PLAN-008380

Proposal: Single storey side extension, two storey front extension & new bay window (resubmission following Y/49/14/HH).

Site: Kingsdene, Yapton Road, Barnham, PO22 0BJ.

Y/101/14/HH

Southern Water MapGuide Browser

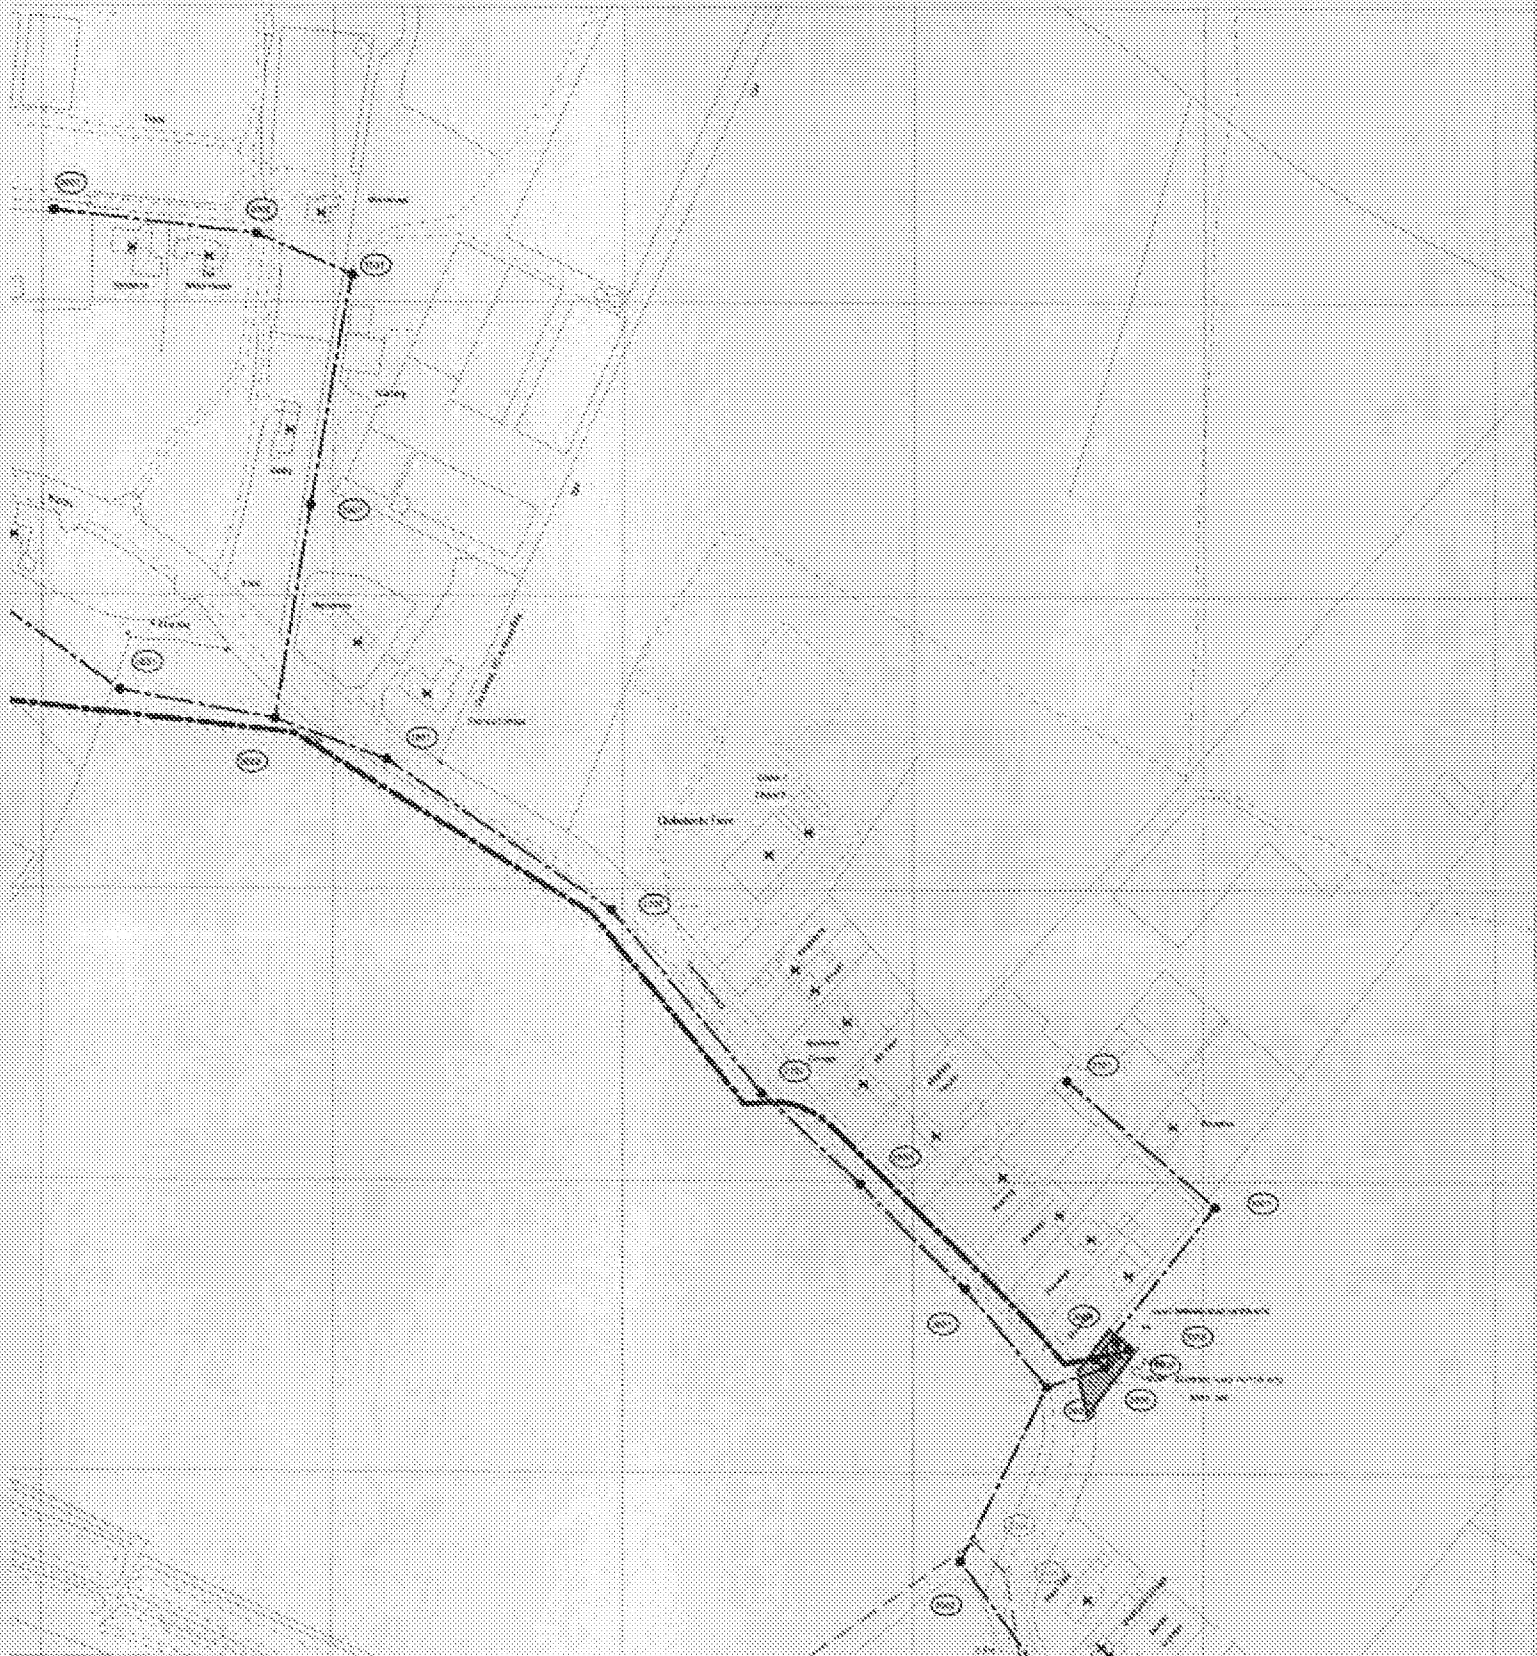
Our initial investigations indicate that there are no public surface water sewers in the area to serve this development. Alternative means of draining surface water from this development are required. This should not involve disposal to a public foul sewer.

Due to changes in legislation that came in to force on 1st October 2011 regarding the future ownership of sewers it is possible that a sewer now deemed to be public could be crossing the above property. Therefore, should any sewer be found during construction works, an investigation of the sewer will be required to ascertain its

condition, the number of properties served, and potential means of access before any further works commence on site. The applicant is advised to discuss the matter further with Southern Water, Sparrowgrove House, Sparrowgrove, Otterbourne, Hampshire SO21 2SW (Tel: 0330 303 0119) or www.southernwater.co.uk".
